INITIAL FIRE SAFETY INSPECTION REPORT

Sweatertech Ltd. (Extension 2)

RSC ID: 26603

Fire Safety Inspection Report

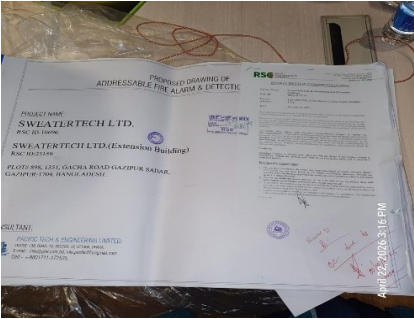
F-19	Means of Egress	Doors in the means of egress do not have the required minimum width. (Available Width: 1st floor-31 in., Ground floor-36 in.) Location(s): ETP.	Doors in a means of egress shall have a minimum width of 1 m (39 in.), in accordance with section 6.5.6.1 of RSC Technical Guidelines (Standard)¹ V1.0.	Within 1 Month
		 April 22, 2026 1:42 PM	 April 22, 2026 1:40 PM
